Proposal for amendments to UN Regulation No. 116 (Protection of vehicles against unauthorized use)

The text reproduced below was prepared by the expert from OICA to amend the definition for keys. The modifications to the current text of UN Regulation No. 116 are marked in bold characters for new and strikethrough for deleted characters.

Fig.1

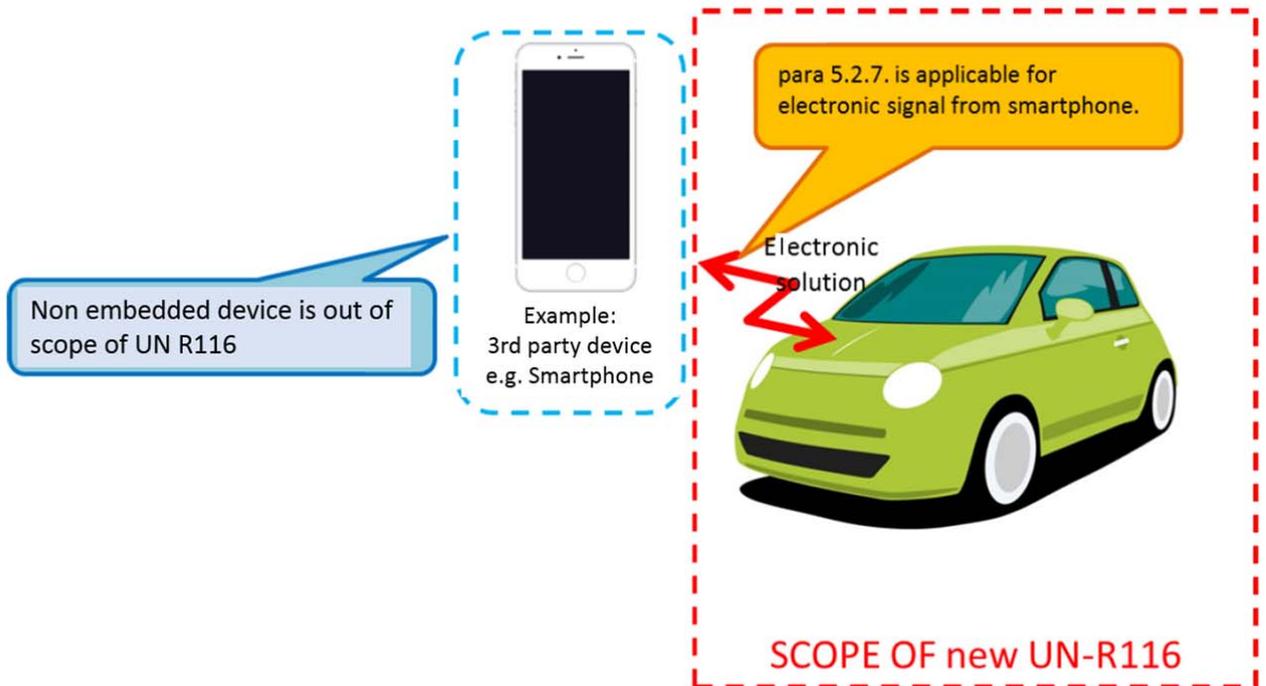
According to the current definition of "key", a smartphone cannot be covered as "only by that device". This is the reason why "electronic solution" is added to definition. The hardware (e.g. smartphone) and software transmitting the electronic solution to the vehicle are not in the scope of UN Regulation No. 116. If the electronic solution is defined as a key, it is reasonable that the electronic solution transmitted from the hardware fulfils the requirements of paragraph 5.2.7. (Electrical/electronic locking systems - See Fig.1)

The proposal introduces a distinction between key as an electronic solution and Hardware and Software used to transfer this electronic solution, and amends UN Regulation No. 116 such that new innovative systems are appropriately addressed in the regulation. New innovative systems use components that are not embedded in the vehicle, this means e.g. devices, hardware, operating systems, communication channels, backend servers which are used for setting or unsetting locking systems, by transferring the electronic solution.

The proposal clarifies that the electronic solution must fulfil the requirements to UN Regulation No. 116 as being a key, while all hardware and software only used for transferring the electronic solution are not covered by the scope of UN Regulation No. 116. Still per paragraph 5.4, the manufacturer must ensure safety of the vehicle.
